APPLICATION NO.	FILING DATE	FIRST NAMED INVENTOR	ATTORNEY DOCKET NO.	CONFIRMATION NO.
10/700,139	11/03/2003	Wayne Van Ethen	1609 - 1	3713

Office Action Summary

This is the first office action for application number 10/700,139, Tube Retainer, filed on November 3, 2003.

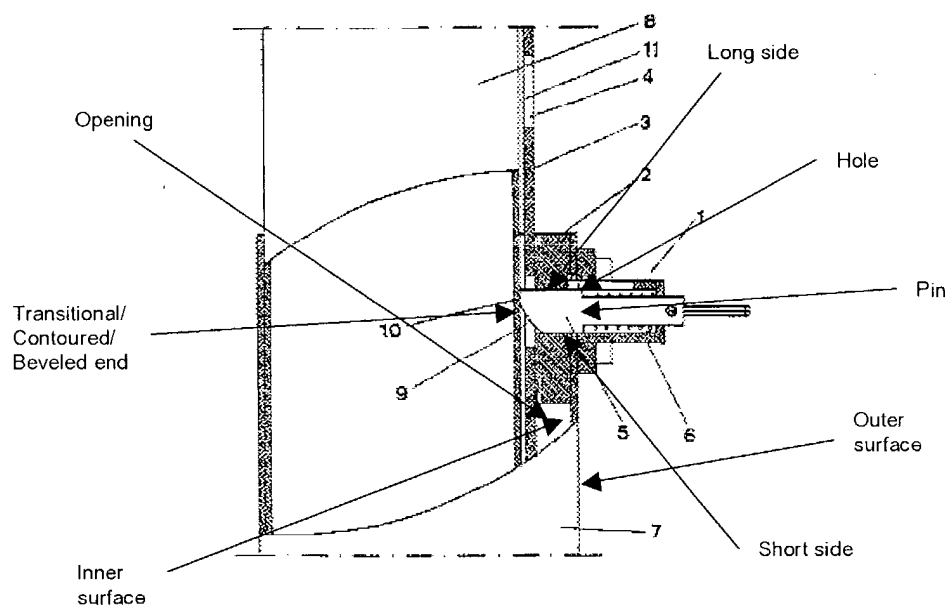
Claims 1, 8 and 9 are rejected under 35 U.S.C. 102(b) as being anticipated by U.S. Patent number 6,398,445 to Matali Badia.

Matali Badia '445 discloses a retainer (above) comprising a cylindrical housing (7, see curved section lines above, further, column 1, lines 14-15 state that traditional systems utilize "tubes" which are defined in Merriam Webster's Collegiate Dictionary - 10th Edition as "any of various... cylindrical structures or devices..."), with an outer surface (above) and an opening (above) through it that is concentrically located in the

housing, the opening having an inner surface (above) and further having at least one hole (above) extending radially from the inner surface to the outer surface, a pin (above) having a top surface (above) and short and long sides (above), the pin being mounted to slide in the hole, the pin further having a transitional end (above) between the long side and the short side, the transitional end extending beyond the inner surface into the opening, and means (6) for forcing the pin toward the opening, wherein the transitional end is a beveled/contoured end.

FIG. 3

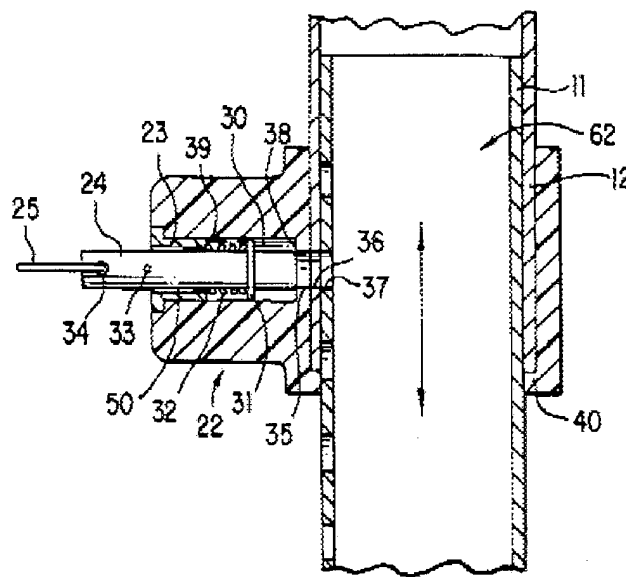
Claims 1, 2 and 4 are rejected under 35 U.S.C. 102(e) as being anticipated by U.S. Patent number 6,575,656 to Suh.

Suh '656 discloses a retainer (above) comprising a cylindrical housing (above, see column 4, lines 36, "circular"), with an outer surface (above) and an opening (above) through it that is concentrically located in the housing, the opening having an inner surface (above) and further having at least one hole (above) extending radially from the inner surface to the outer surface, a pin (above) having a top surface (above) and short and long sides (above), the pin being mounted to slide in the hole, the pin further having a transitional end (above) between the long side and the short side, the transitional end extending beyond the inner surface into the opening, and means (6) for forcing the pin toward the opening, wherein the hole has an upper section (above) with a cross-sectional area and a lower section (above) with a cross-sectional area smaller

that that of the upper section, wherein the cylindrical housing has a groove (above) located about the outer surface.
